Fargo VAMC – Refurbish Elevators and Replace Controls

Fargo, North Dakota
Project #19-2481

MARCH 26, 2024

ADDENDUM NO. 2

4 FLOOR PLAN - INDEPENDENCE 4,5 - PIT DEMOLITION
1/4" = 1'-0"

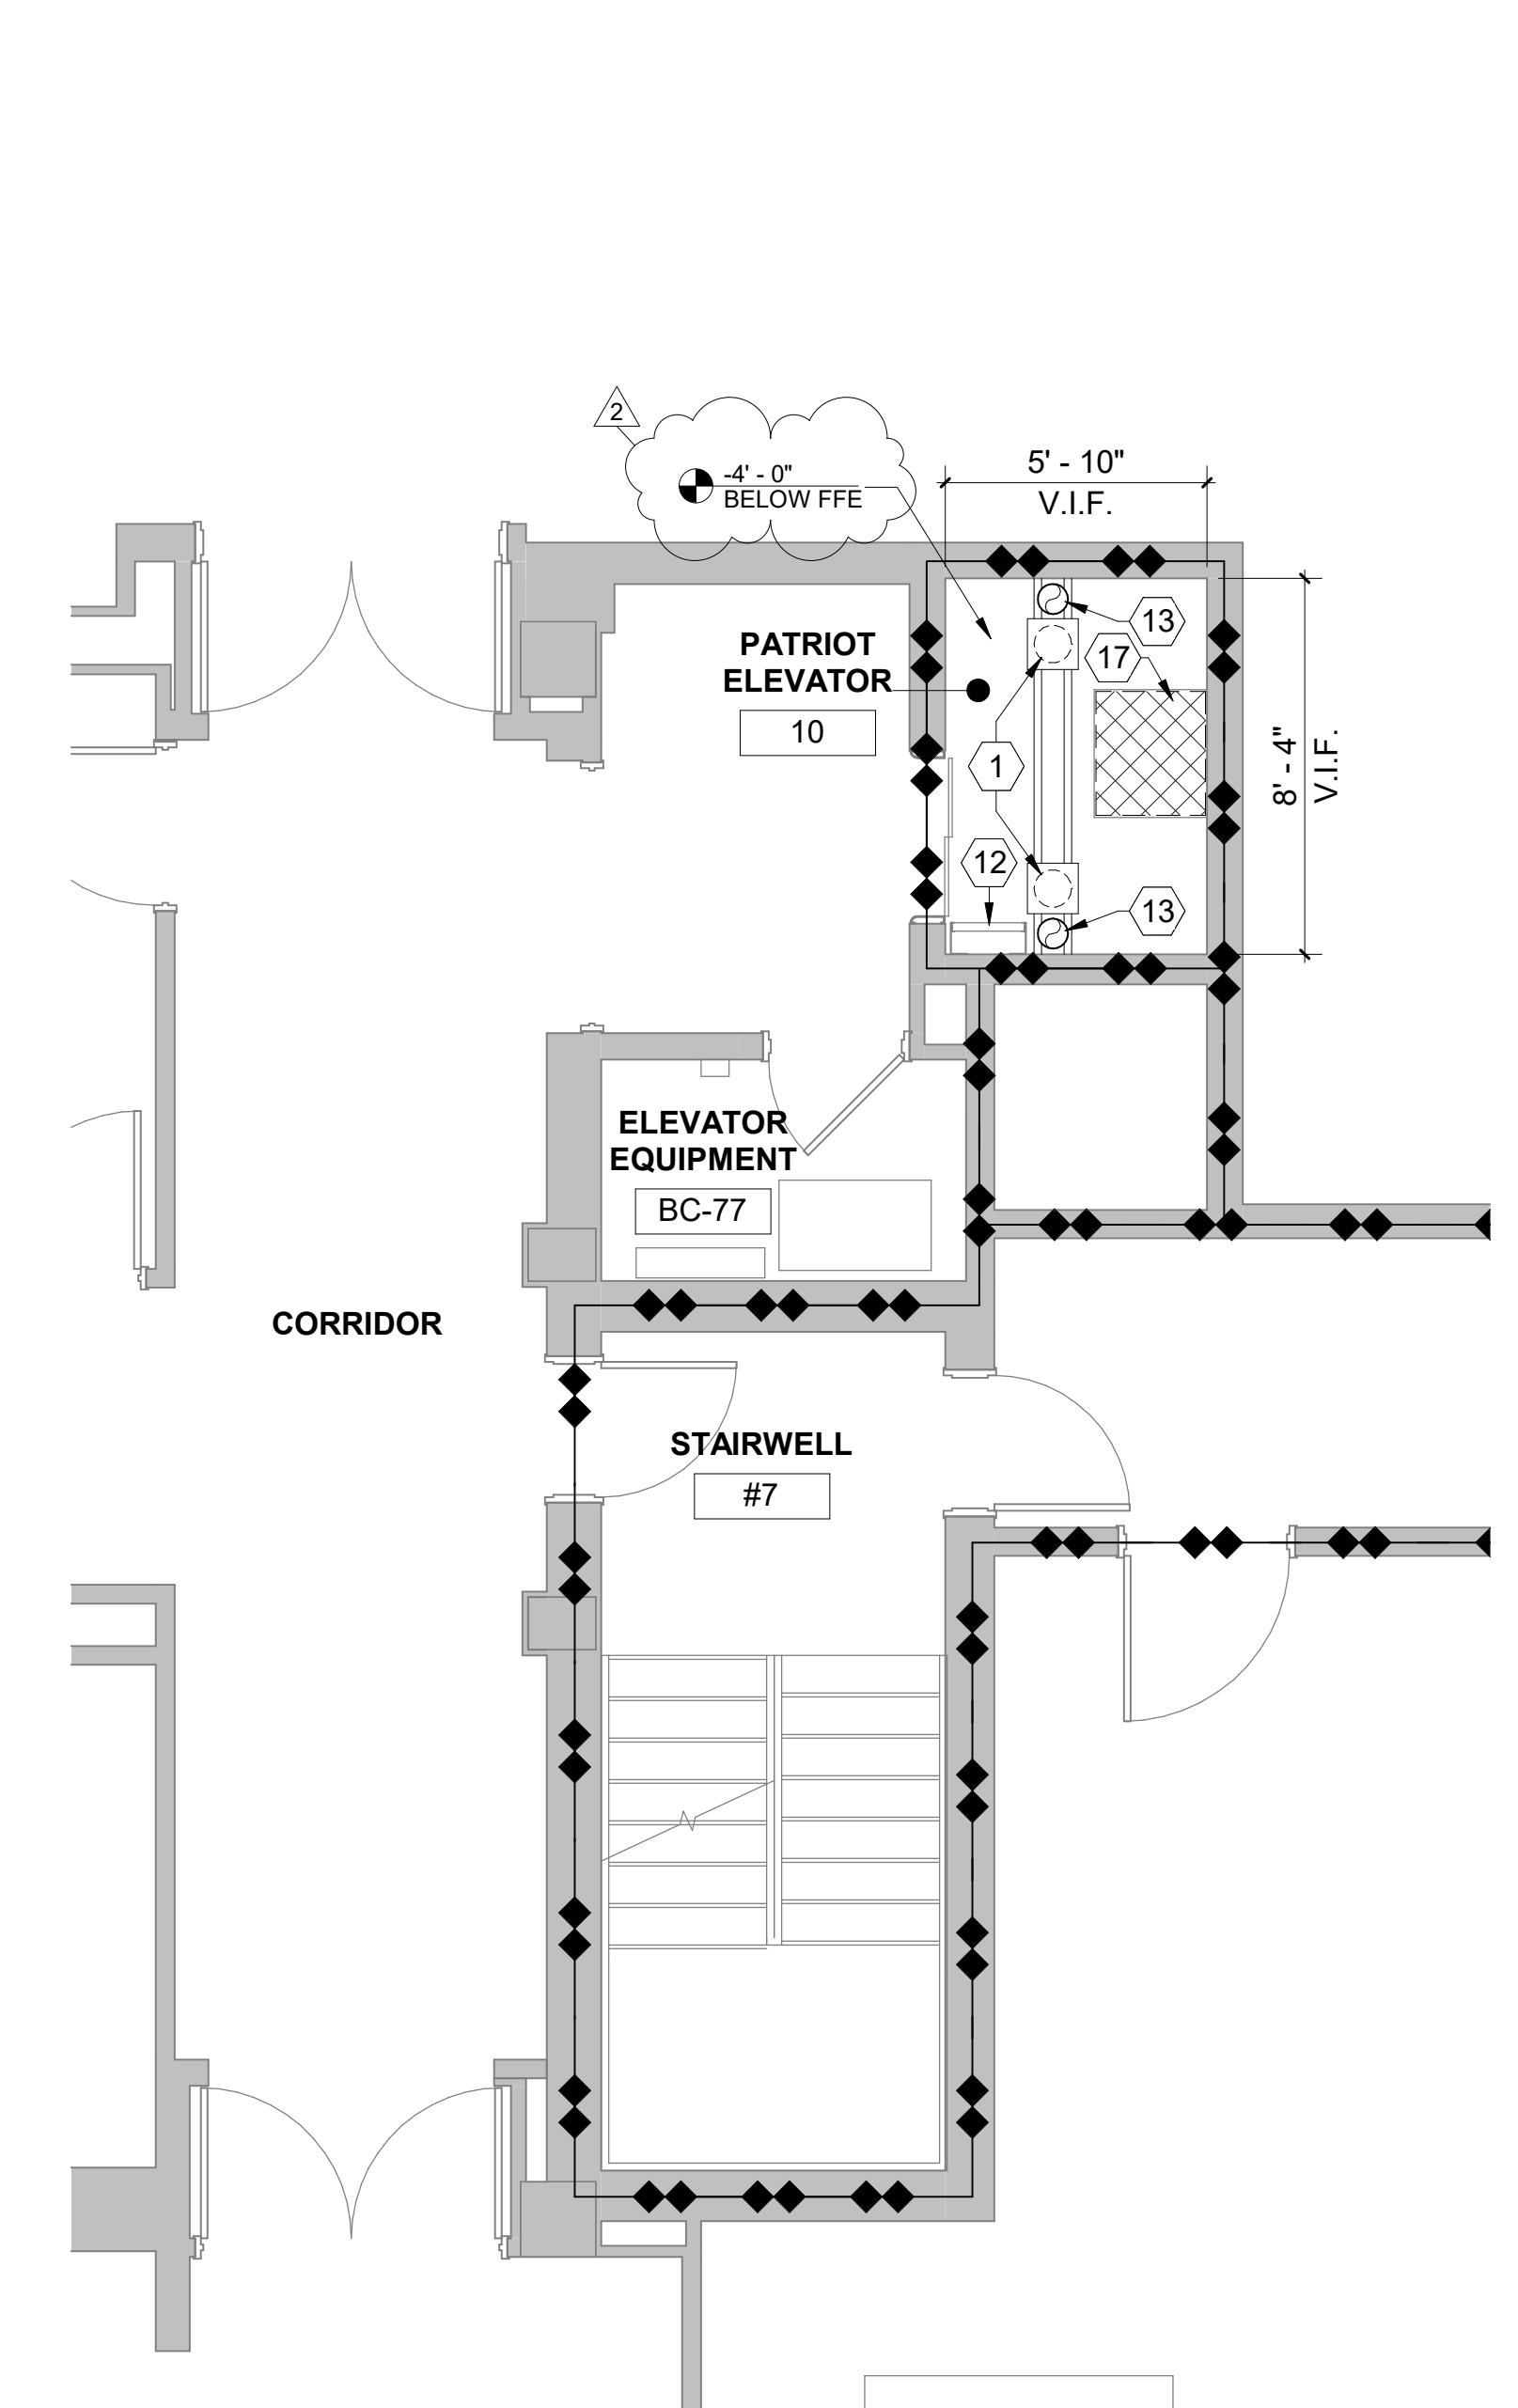
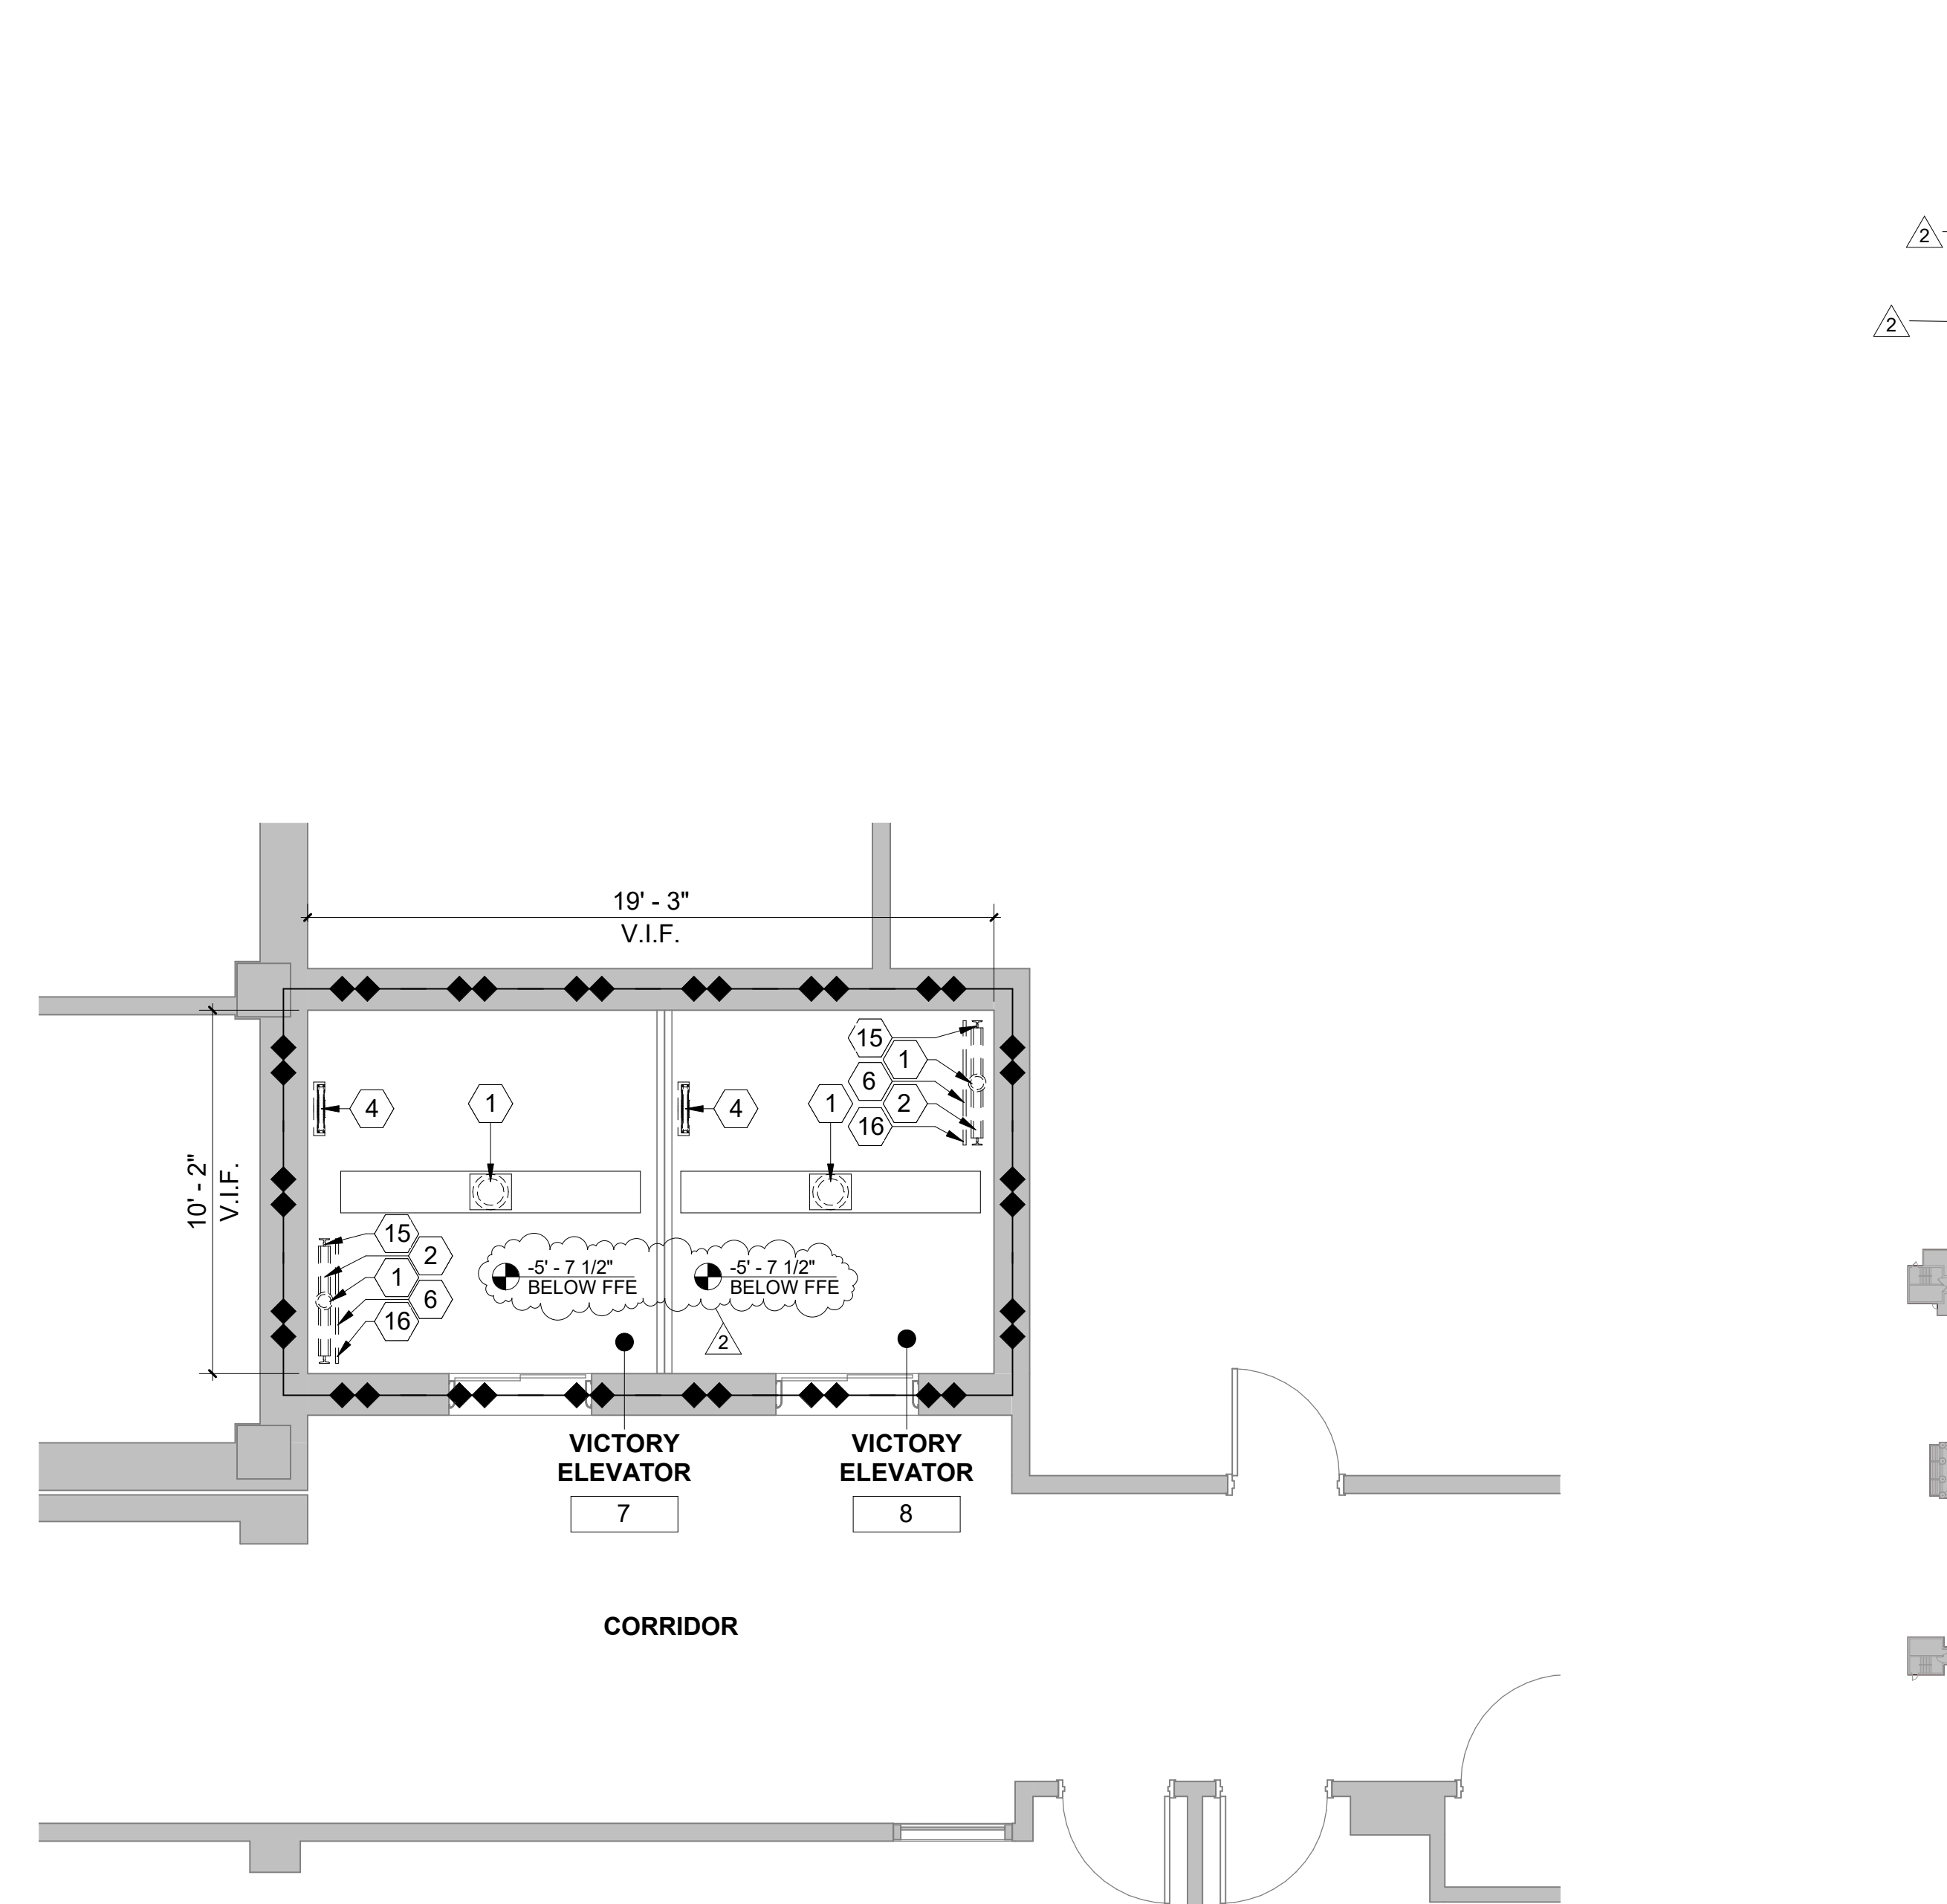
Drawing Sheet AD5.20 ENLARGED PLANS - DEMOLITION – See revised drawing sheet for the adjustment of keynotes # 3, 9, 13 15, 16. Also included is the depth of each elevator pit relative to the floor elevation at the lowest elevator lobby for each hoistway.

- EXISTING METAL PIT LADDER TO REMAIN.
- EXISTING HYDRAULIC PISTONS/JACKS TO REMAIN AND BE REPACKED.
- NOT USED.
- EXISTING LOWER SECTION OF GUIDE RAILS TO BE REMOVED AND REPLACED (APPROX 20LF AT EACH RAIL). INSTALL TO COORDINATE WITH OTHER NEW EQUIPMENT. PROVIDE NEW MOUNTING BRACKETS. APPLIES TO ELEVATOR 7 AND 8 ONLY DUE TO WATER DAMAGE.

- EXISTING LOWER SECTION OF COUNTERWEIGHT RAILS (APPROX 20 LF AT EACH RAIL) AND PIT GUARD TO BE REMOVED AND REPLACED. INSTALL TO COORDINATE WITH OTHER NEW EQUIPMENT. PROVIDE NEW MOUNTING BRACKETS. APPLIES TO ELEVATOR 7 AND 8 ONLY DUE TO WATER DAMAGE.
